LOT GRADING REVIEW

LOT/BLK. NO.(S) Lot 38

LECCO RIDGE DEVELOPMENTS INC.

LOT No. 38

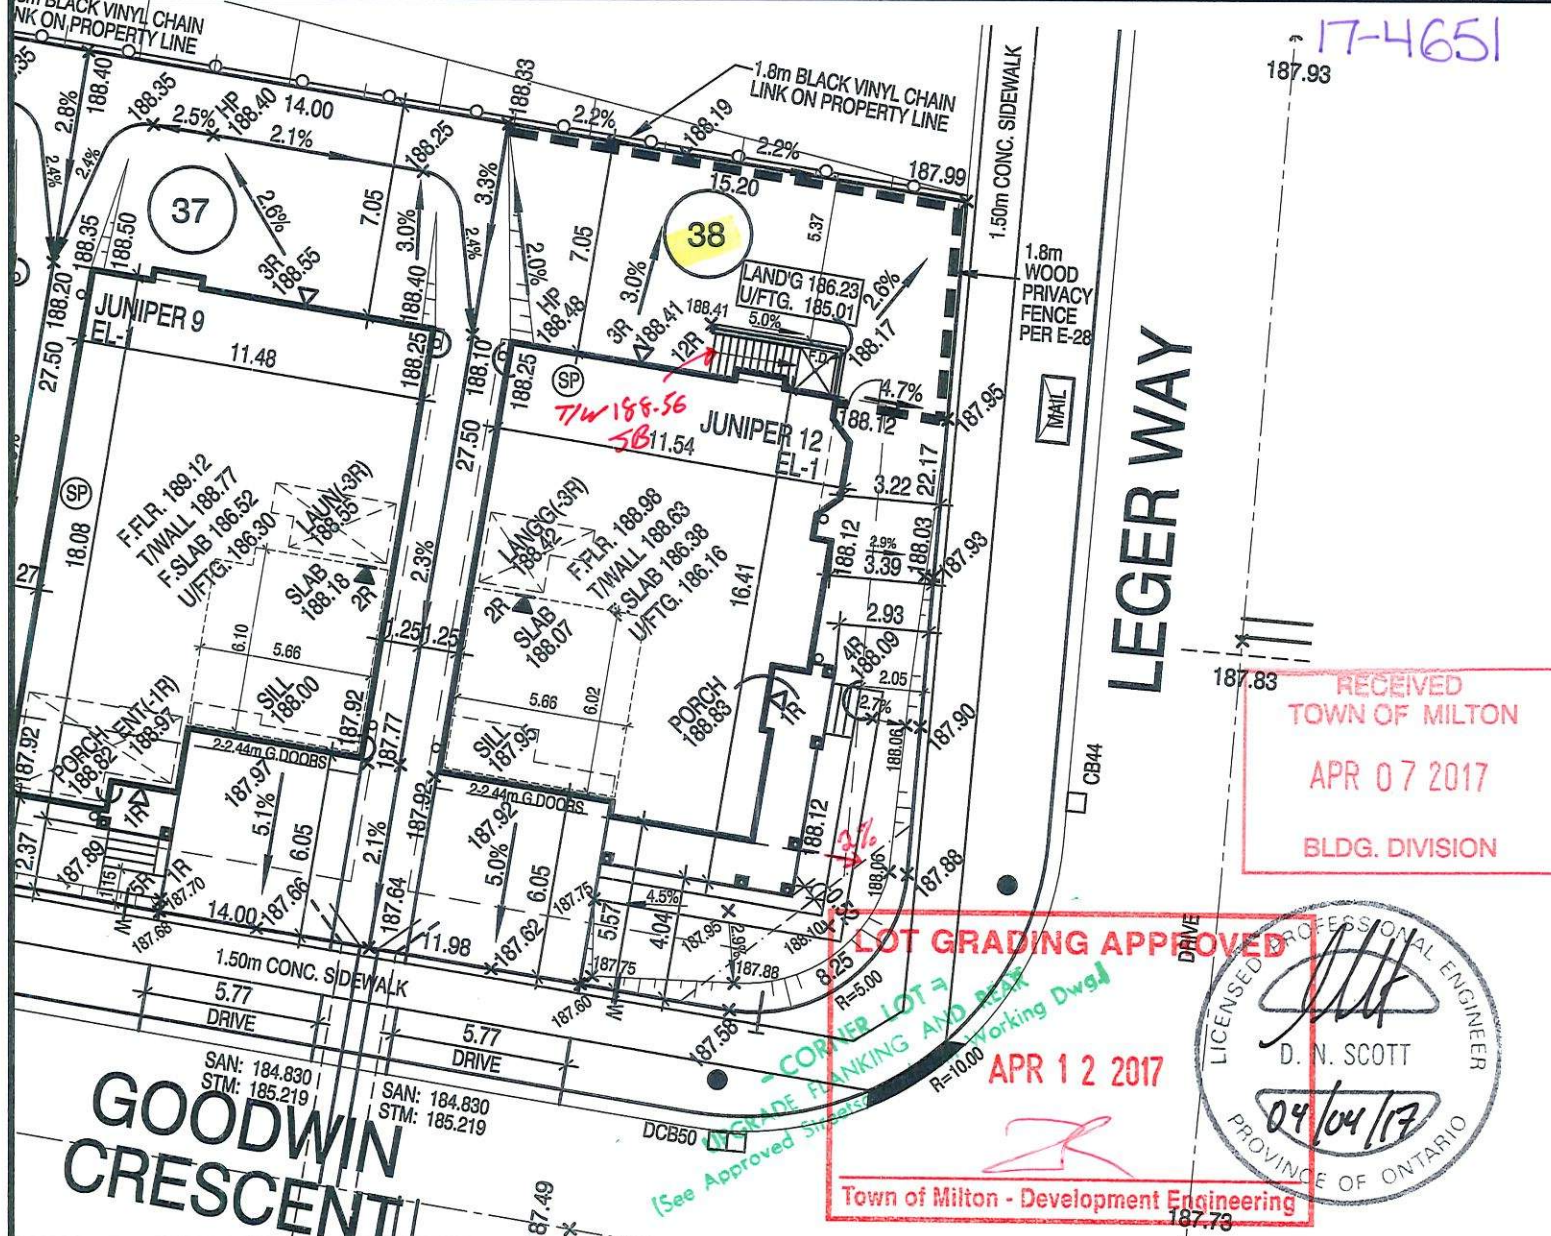
45 Min FRR

45 Min FRR w/NC Cladding

Guard/Handrail as per 9.8.

2.1 m Backfill height as per 9.15.

Siting to be read in conjunction with reviewed main model drawings
